Horizon West Transmission and Pacific Gas and Electric Company

Estrella Substation and Paso Robles Reinforcement Project

Proponent's Environmental Assessment (A.17-01-023)

Response to Data Request No. 2

Exhibit 2-13b. Soils Map for SS-1 and PLR-1C

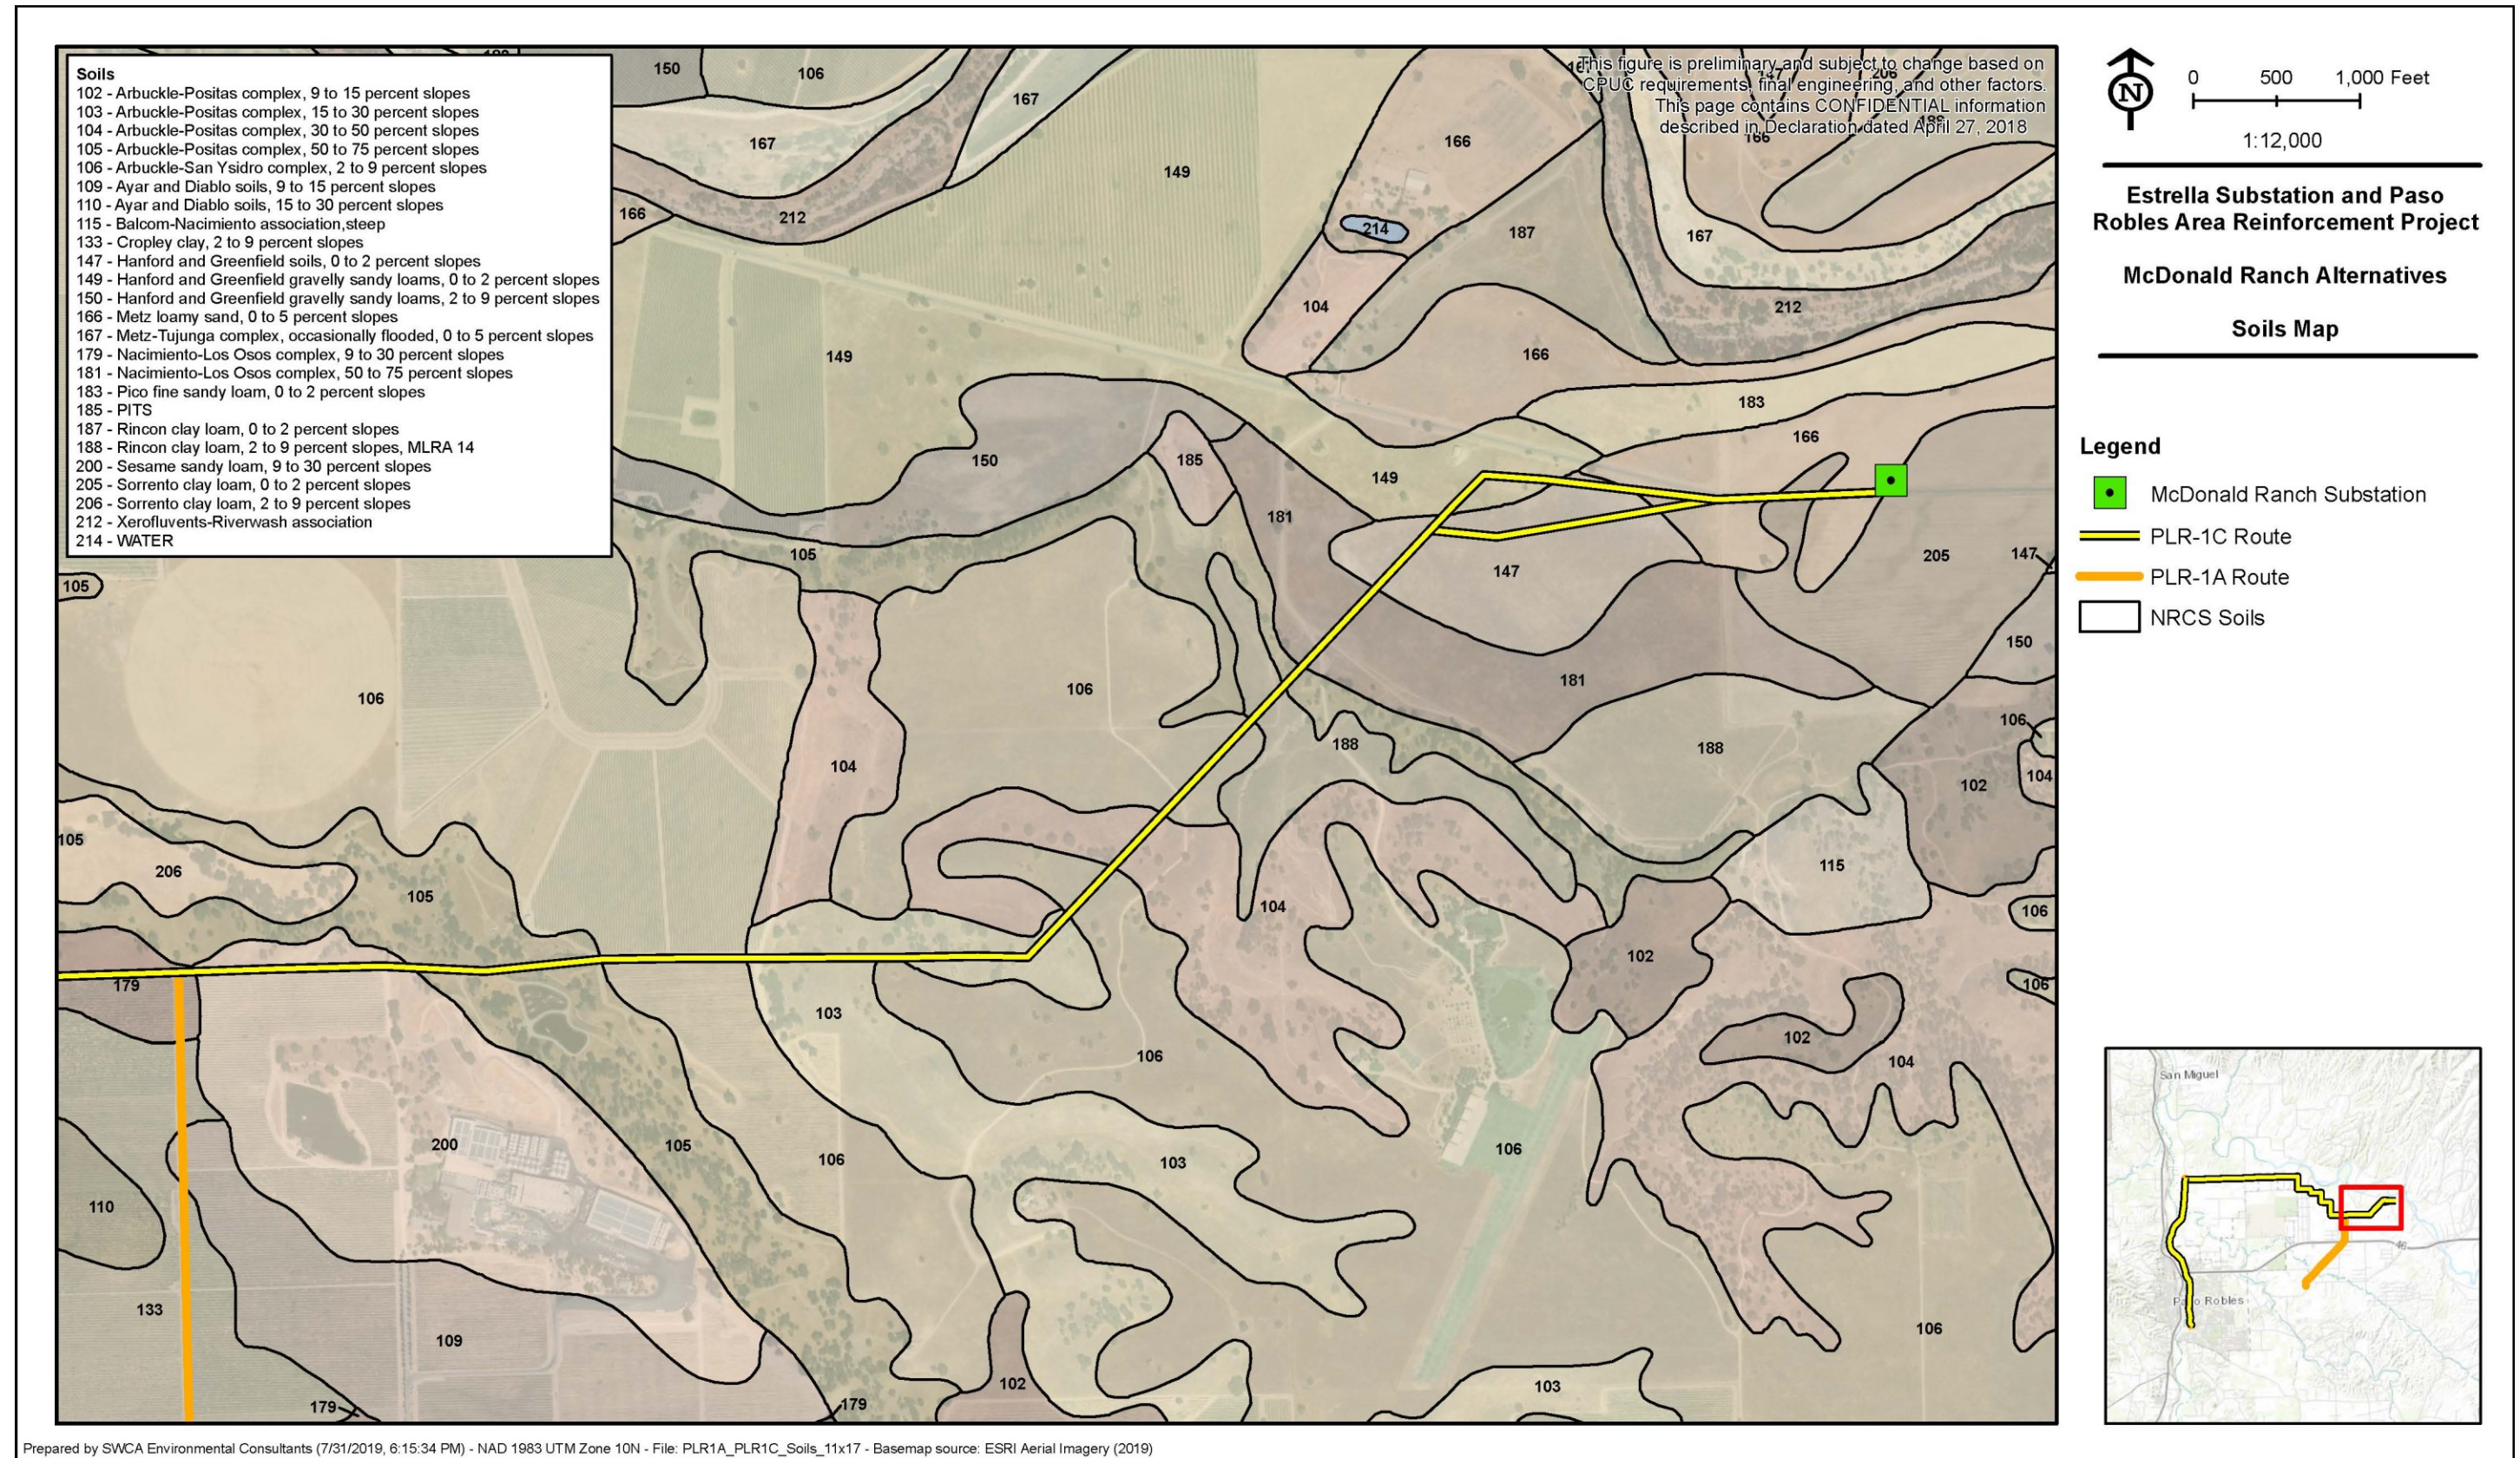
For Alternatives SS-1, PLR-1A, PLR-1C, and PLR-1D, please provide soils maps and a geo-archaeological analysis to indicate the presence of paleontological resources. This information was provided for the Templeton Expansion Alternatives as part of the response to Deficiency Letter No. 4, but similar information is needed for the remaining alternatives. Please also provide a record search for paleontological resources for Alternatives SS-1, PLR-1A, PLR-1C, and PLR-1D.

Soils, geology, and geology and sensitivity maps for Alternatives PLR-1A were provided in the BRTR and Paleontological Resources Technical Report (PRTR) submitted to the CPUC on April 23, 2019. Soils, geology, and geology and sensitivity maps for Alternative SS-1 and PLR-1C are provided in Exhibits 2-14a, 2-14b, and 2-14c, respectively. Soils, geology, and geology and sensitivity maps for Alternative PLR-1D will not be provided because the CPUC indicated on our call on June 12, 2019 that this alternative has been eliminated. GIS data associated with the BRTR and PRTR for Alternative PLR-1A, and Exhibits 2-14a, 2-14b, and 2-14c for the Alternatives SS-1 and PLR-1C will be provided separately.
